## ADDENDUM NO. ONE (1)

SIGN-IN SHEET for ITB#6- 2016/2017 GCSC SOFTBALL COMPLEX PROJECT

4 HOME DUGOUT SECTION 3/8" = 1'-0"

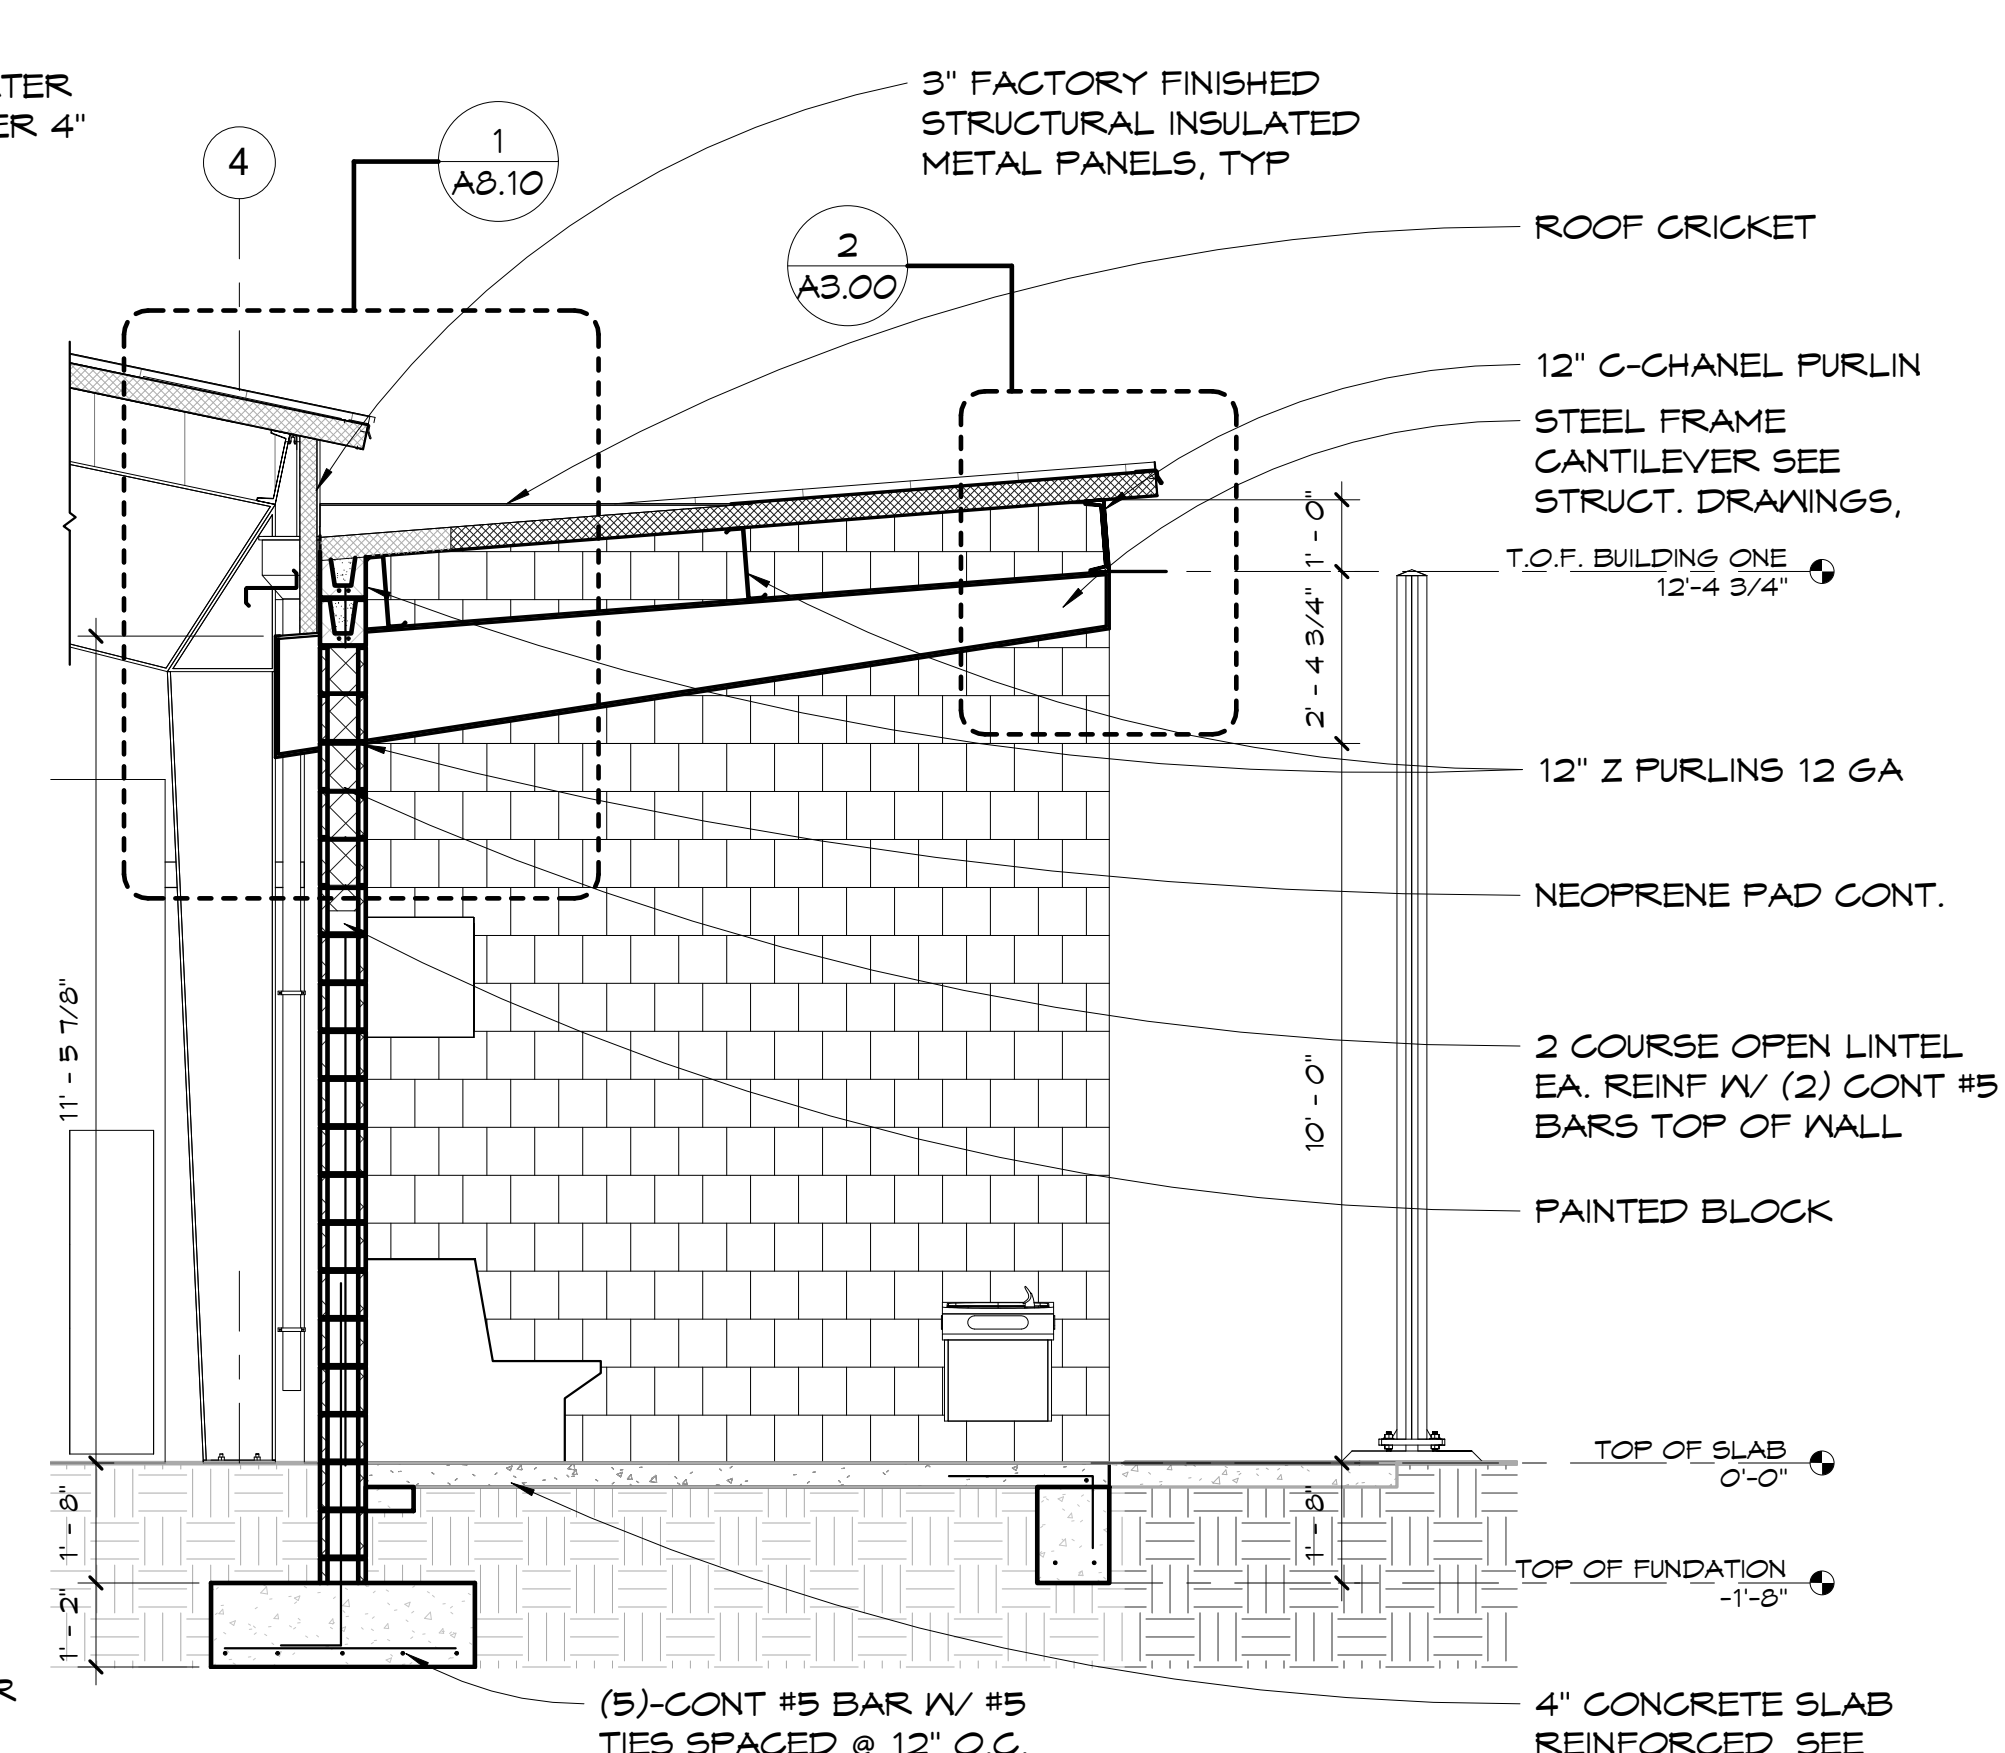
Item No. 7A: Refer to Drawing Sheet A3.00, Sections And Details - **DELETE** H.D.'s (Hand Dryers). Notes with respect to the Metal Building Manufacturer were modified (DELETE "By Others"). Metal Building to be by Contractor.

HVAC FLOOR PLAN - NEW WORK

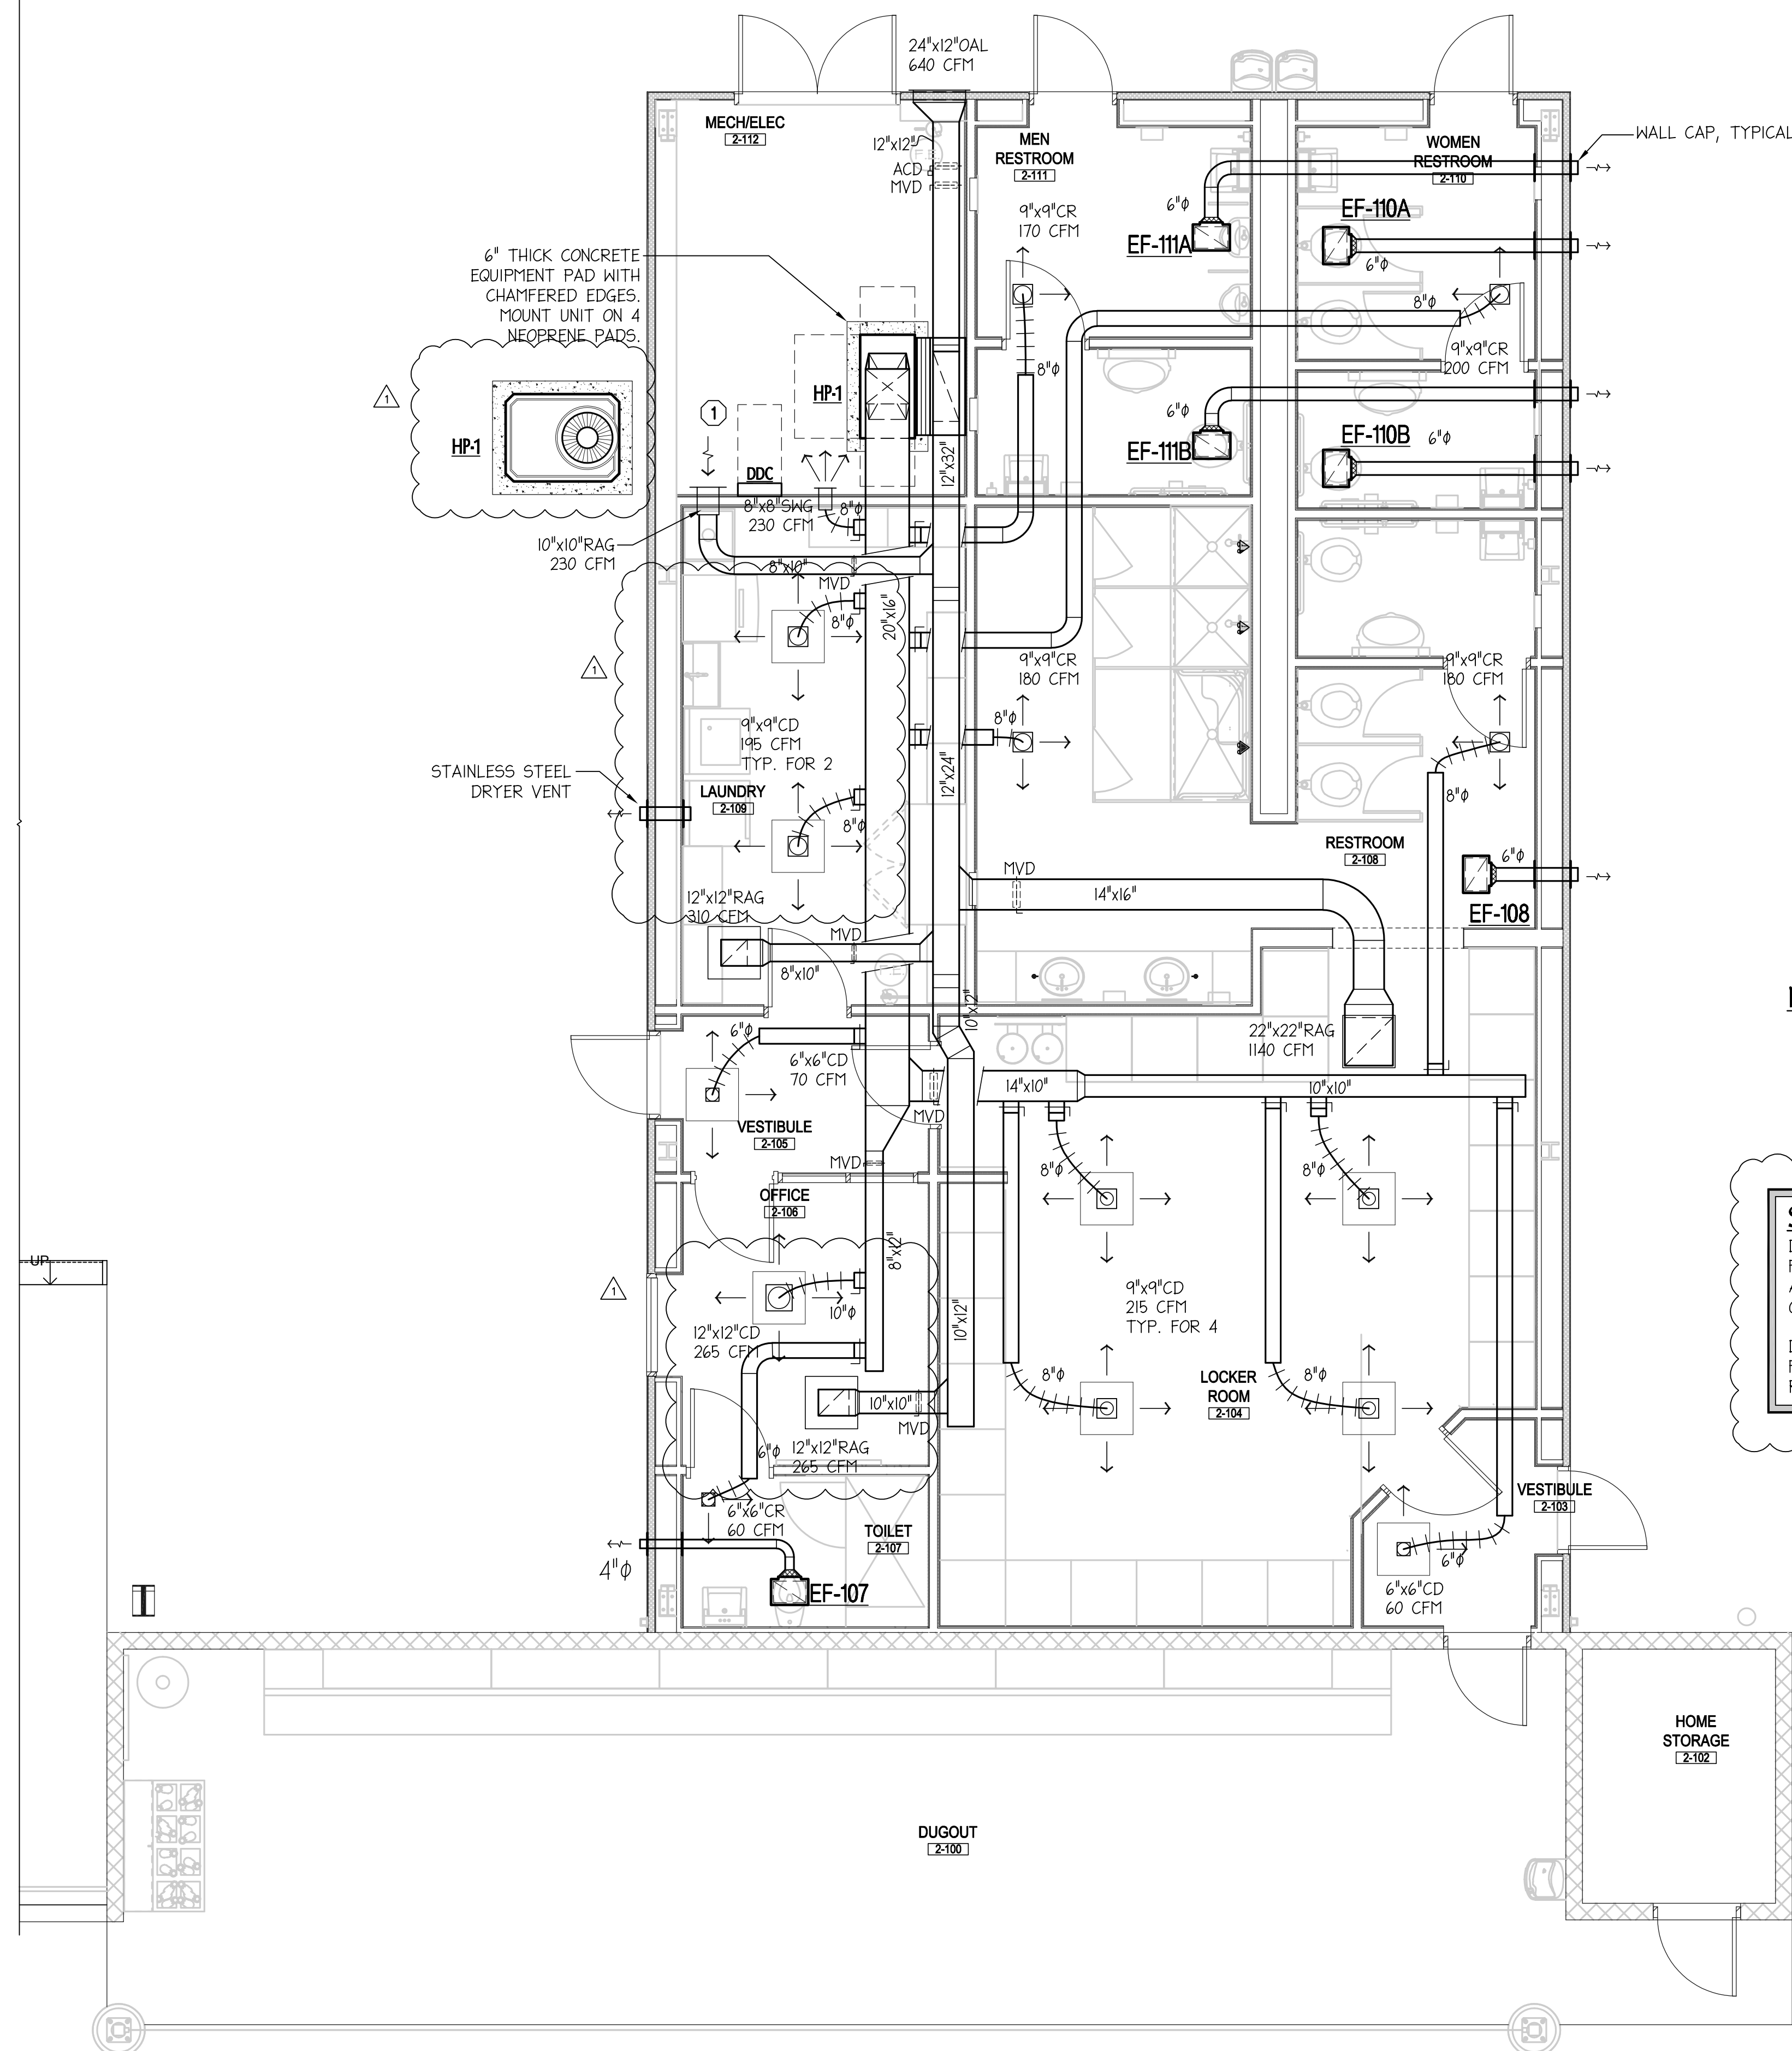
Item No. 2M: Refer to Drawing Sheet: M3, HVAC Floor Plan - New Work: **ADD** Sequence of Operations for Locker Room heat pump.

**ELECTRIC WATER HEATER INSTALLATION DETAIL**

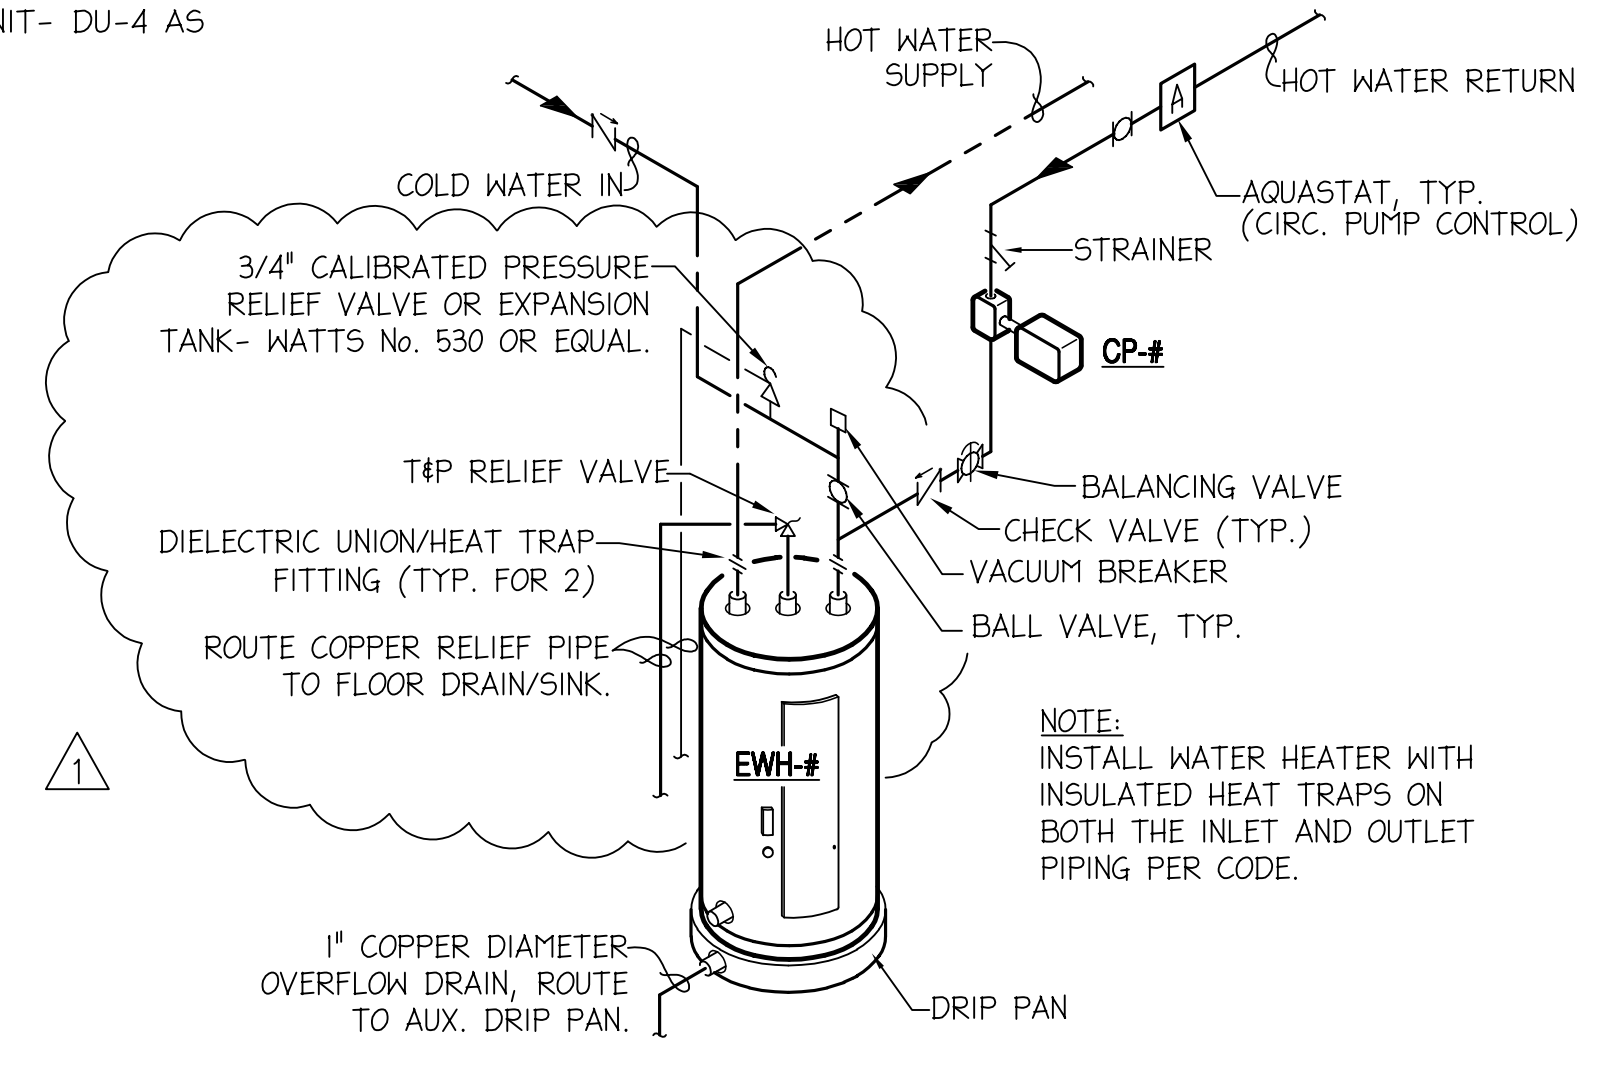
Item No. 2P: Refer to Drawing Sheet P2, Plumbing Details: **CHANGE** Electric water heater detail.
